Docket No. 50-508

October 27, 1982

Subject: SUPPLY SYSTEM NUCLEAR PROJECT NO. 3
ENVIRONMENTAL REPORT - OPERATING LICENSE STAGE
RESPONSE TO NRC ACCEPTANCE REVIEW QUESTIONS

RESPONSES TO NRC OL ACCEPTANCE REVIEW
QUESTIONS OF AUGUST 20, 1982 (Re: WNP-3 ER-OL)

<p>WASHINGTON PUBLIC POWER SUPPLY SYSTEM NUCLEAR PROJECT No. 3 OPERATING LICENSE ENVIRONMENTAL REPORT</p>	<p>HYDROLOGIC FEATURES NEAR WNP-3</p>	<p>FIGURE 2.4-2</p>
---	---------------------------------------	-------------------------

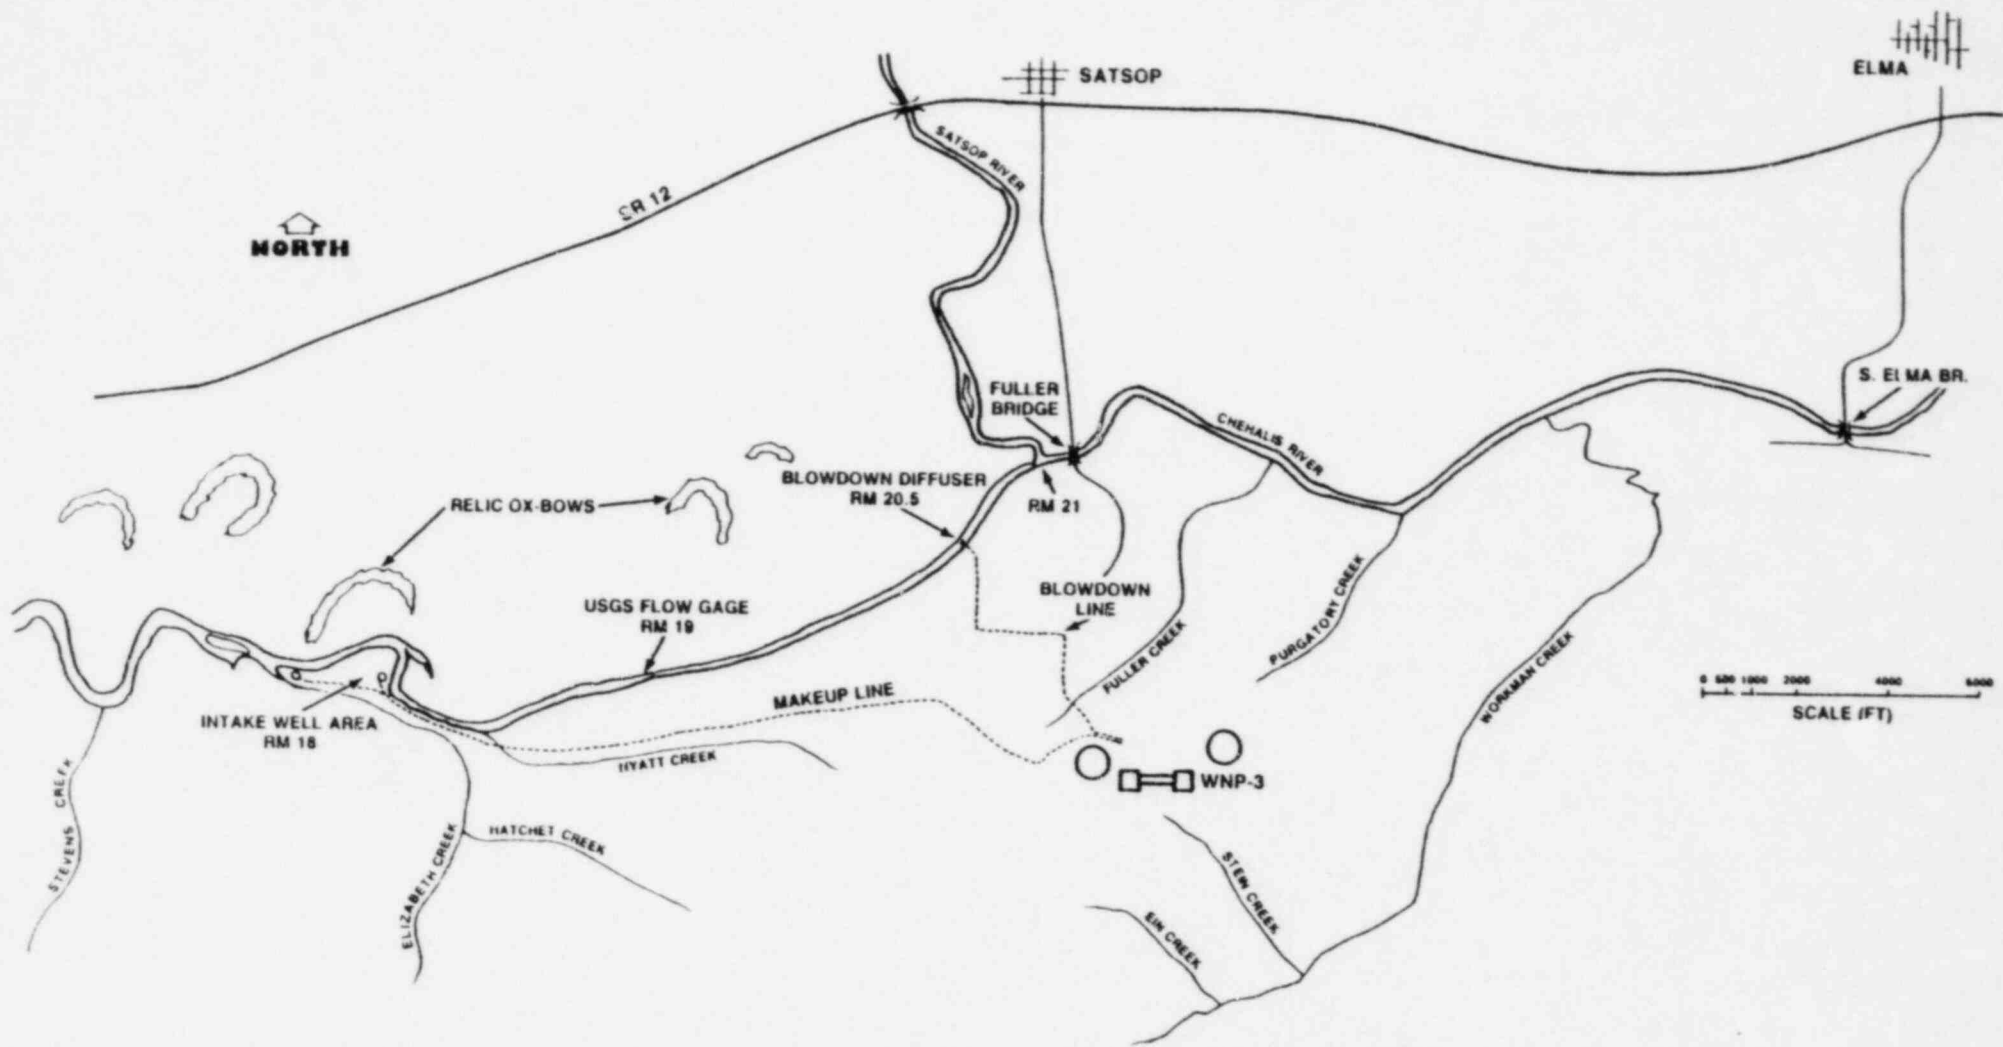
- 240.03 Q. For a more complete and useful hydrologic description, the figures need to reflect all items mentioned in the text. The locations of specific river mile (RM) marks and gaging station mentioned in the description (p. 2.4-1) need to be marked on the figures.

- 291.09 Q. Provide the location on a map of the blowdown diffuser in relation to the Chehalis River, Ranny Collectors and the plant. Also provide an overhead view of the section of river in which the diffuser is located. On this figure differentiate between the blowdown diffuser section and the supply pipeline.

- A. See Figure 2.4-2, as amended.
- 240.04 Q. What is the exact location (please show in appropriate figures) of the place called "near the site" (pp. 2.4.1- and 2.4.2)?

- A. See Figure 2.4-2, as amended, for relative locations of the intake and diffuser. Figure 3.4-7 provides a plan view of the river with diffuser.
- 291.10 Q. Section 3.4.4 describes a 32-foot multiport diffuser. Figure 3.4-4 shows a 34-foot long length of pipe that is presumably the diffuser since section A-A shows a discharger riser. Resolve this difference and indicate on Figure 3.4-4 that portion of the pipeline that is the blowdown diffuser.

FIGURE 2.4-13

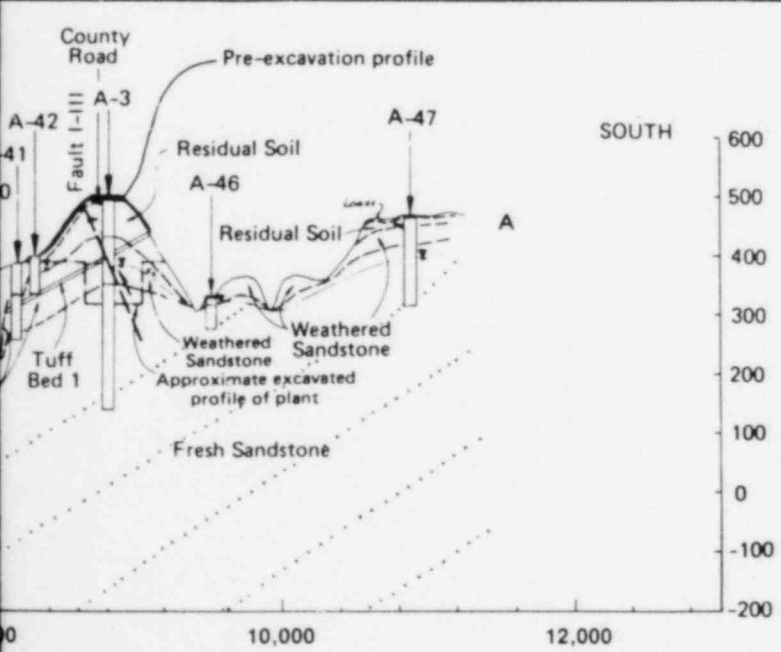
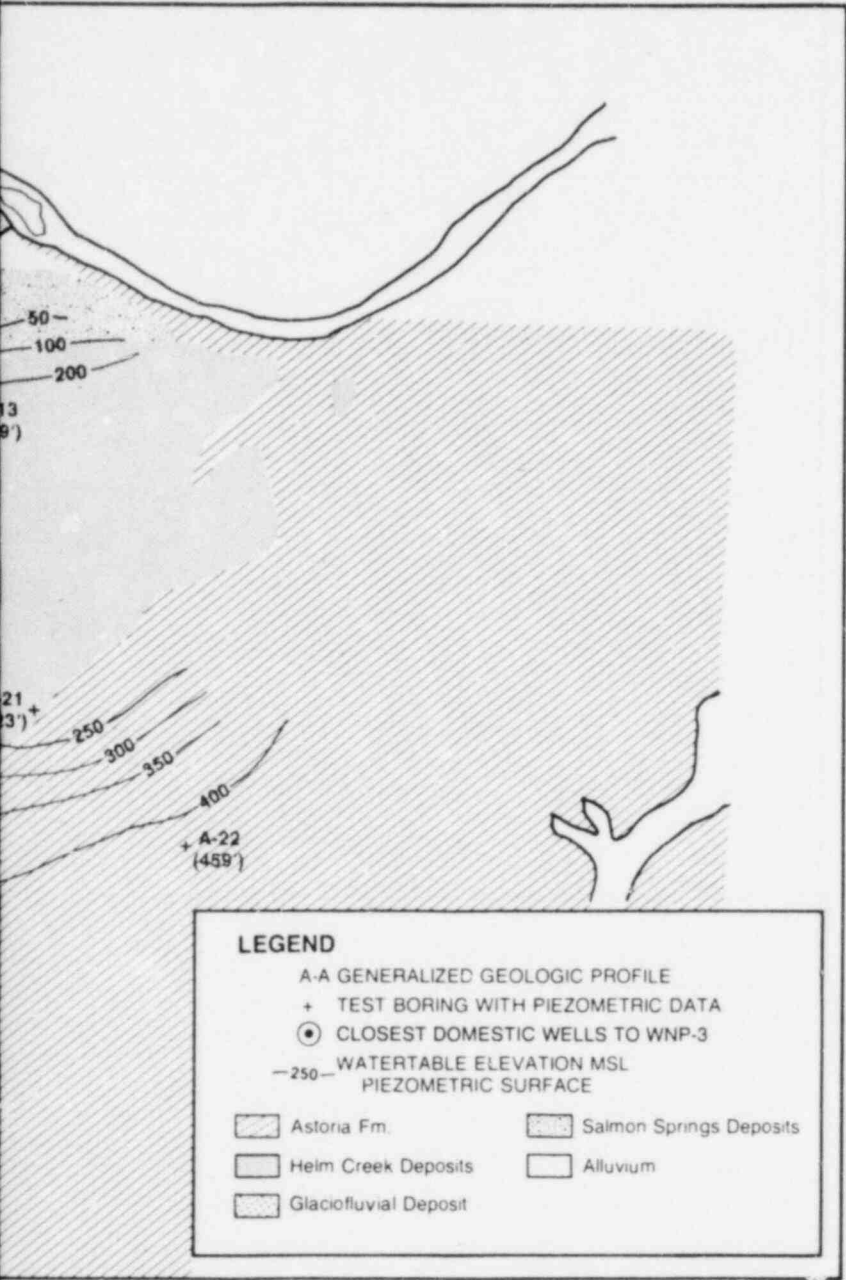
240.07 Q. For an evaluation of ground water flow in the vicinity of the plant site, maps and cross sections are needed of the geologic formations and aquifer. These should encompass the plant site and nearest (by travel time of ground water) individual and public use of the ground water. Locations of these users should be indicated.

Provide information on the piezometric level, hydraulic gradients, permeabilities, transmissivities, storage coefficients, flow times, and adsorption properties for each of the soil or geologic units in the area of interest.

A. A map of the pre-construction water table and a generalized geologic profile, based on data reported in Appendix 2.5A of the Final Safety Analysis Report (FSAR), are provided in Figure 2.4-13. Estimated permeabilities for each of the formations are indicated on the figure. Three domestic wells nearest the plant are also shown on the figure. Two produce about 10 gpm from the upper terrace and the third produces about 20 gpm from the lower terrace deposit. There are no public water supplies in the zone of groundwater flows potentially impacted by plant operation. Groundwater travel time through the Astoria Formation to the nearest well, about 5,000 feet northward, is about 1900 years with a hydraulic gradient of 0.042 and a porosity of about 0.35 (FSAR Table 2.5-16). Flows entering the overlying Helm Creek Formation would be intercepted by Fuller Creek. Wells on the north side of the river would not intercept flows originating at the plant as the hydraulic gradient there is to the southwest.

<p>WASHINGTON PUBLIC POWER SUPPLY SYSTEM NUCLEAR PROJECT No. 3 OPERATING LICENSE ENVIRONMENTAL REPORT</p>	<p>RANNEY GROUNDWATER COLLECTOR</p>	<p>FIGURE 3.4-6</p>
---	-------------------------------------	-------------------------

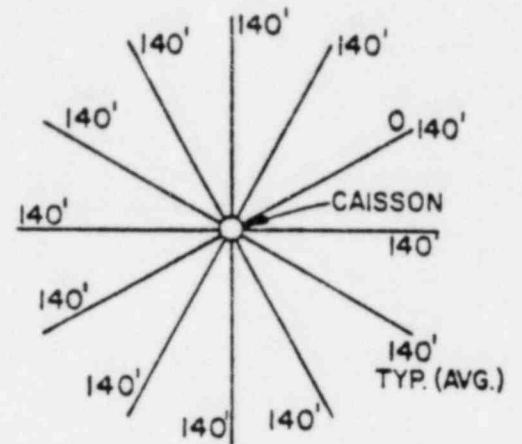
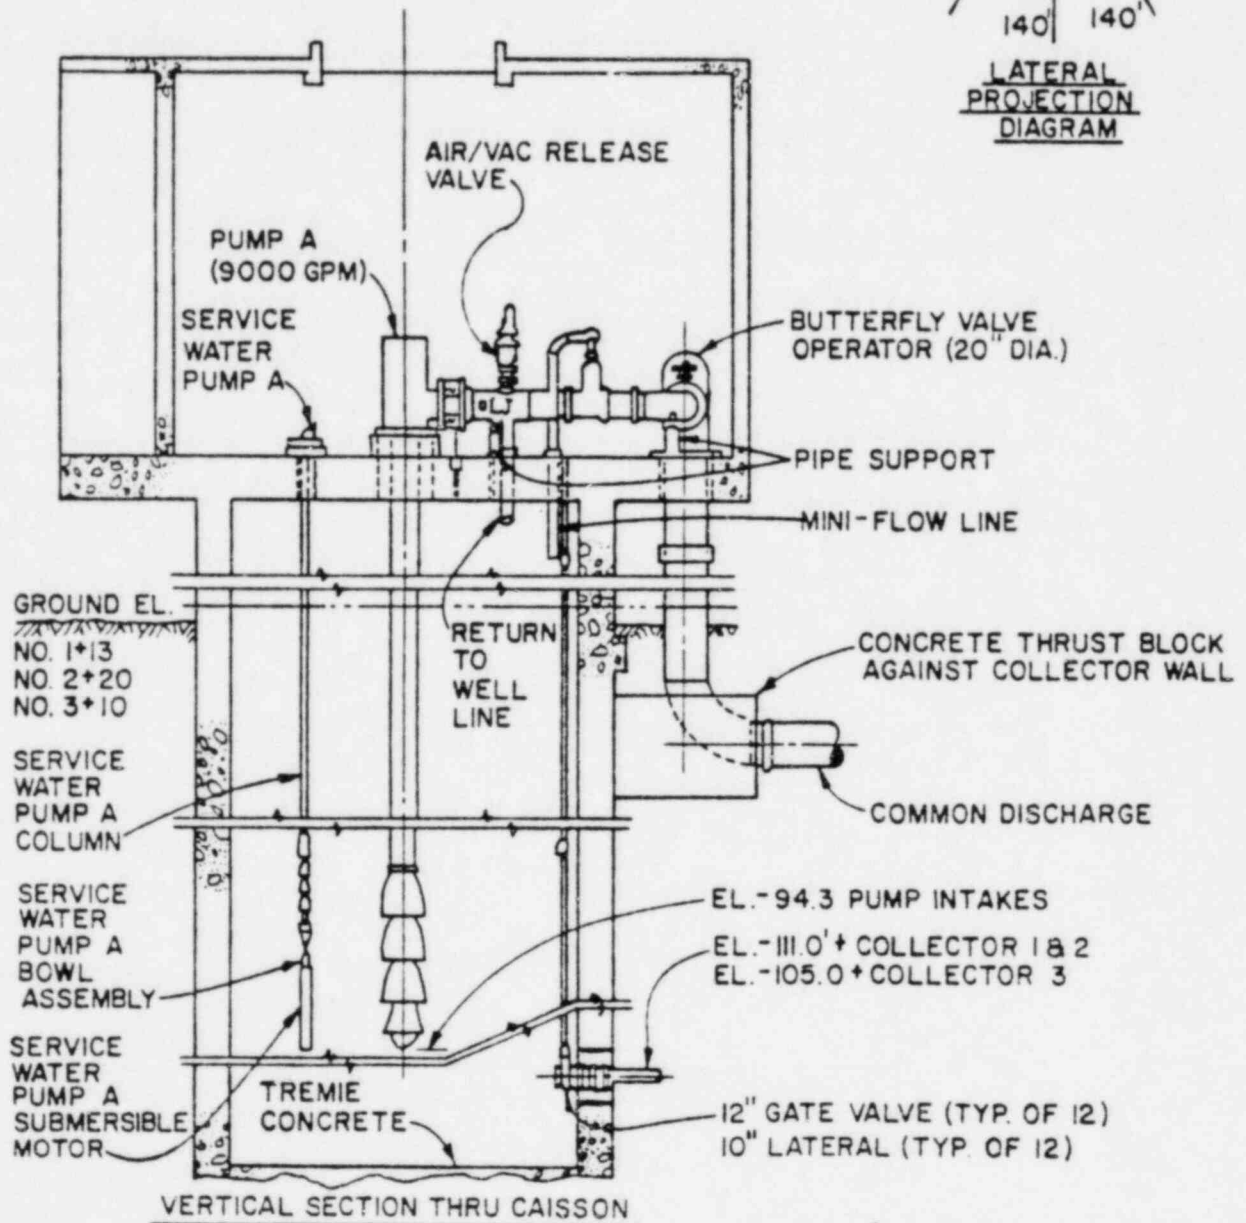
- A. Subsection 2.2.2.6 (now Subsection 2.2.2.5) has been amended with a discussion based on available information.
- 291.05 Q. Amend Figure 3.4-6 by providing the elevation of the intakes of each of the circulating water intake pumps located in the Ranny Well intake cassettes.

- A. Figure 3.4-6 has been amended.
- 291.06 Q. Figure 3.4-6 shows a service water pump. Figure 3.4-1 shows flow to the RBCCWHx and the service water pump drawing from the circulating water pumps located downstream of the cooling tower. Describe the use of the service water obtained from the service water pumps in the Ranny Collectors.

<p>WASHINGTON PUBLIC POWER SUPPLY SYSTEM NUCLEAR PROJECT No. 3 OPERATING LICENSE ENVIRONMENTAL REPORT</p>	<p>SCHEMATIC DIAGRAM OF CIRCULATING COOLING WATER SYSTEM</p>	<p>FIGURE 3.4-1</p>
---	--	-------------------------

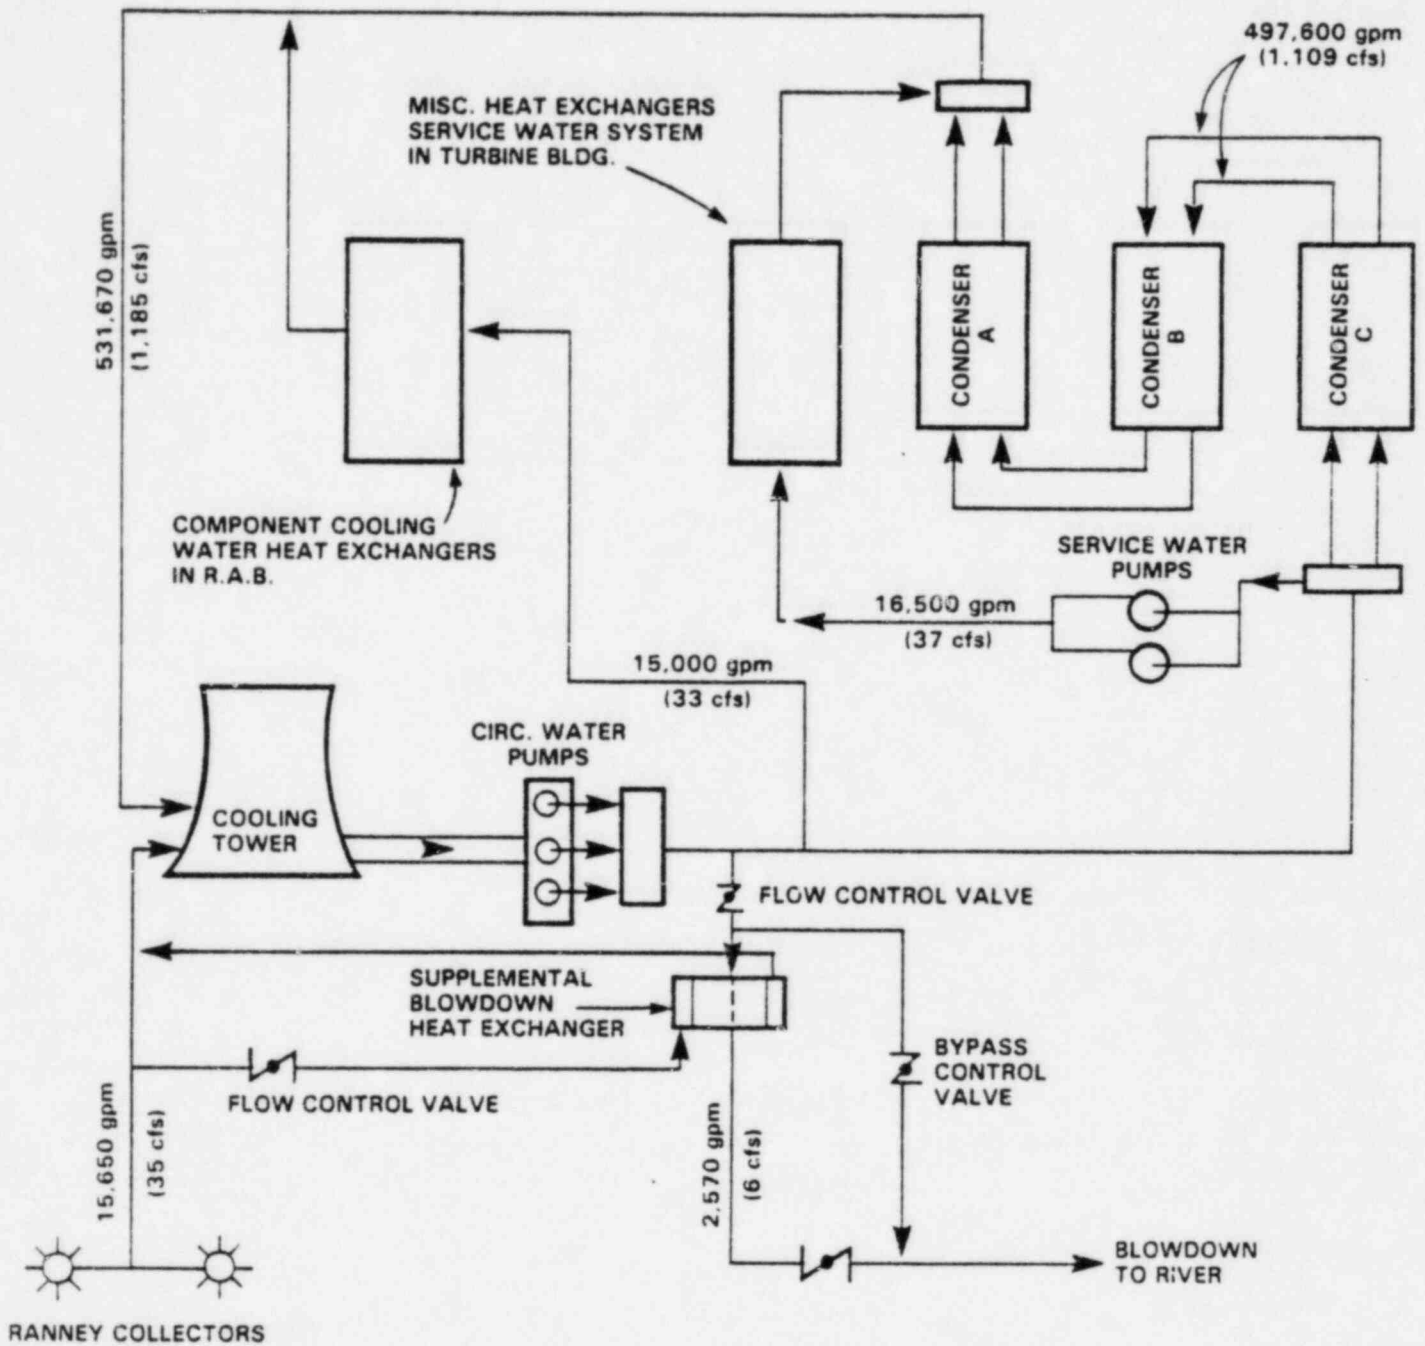
- 291.08 Q. Provide additional detail for the supplemental cooling system (Subsection 3.4.3). Indicate its location on a site map. Provide a schematic drawing of the unit. Given an estimate of its usage on an annual basis. Provide the criteria that determine its usage.
- A. The supplemental cooling system is a shell and tube heat exchanger with makeup water flow through the tubes. Its location, just west of the WNP-3 cooling tower, is shown on Figure 3.1-3. A schematic drawing of the unit is included on Figure 3.4-1. Usage is required by the thermal effluent limitations of the NPDES Permit (see Appendix A) which are noted in Subsection 5.1.1. These require that when the
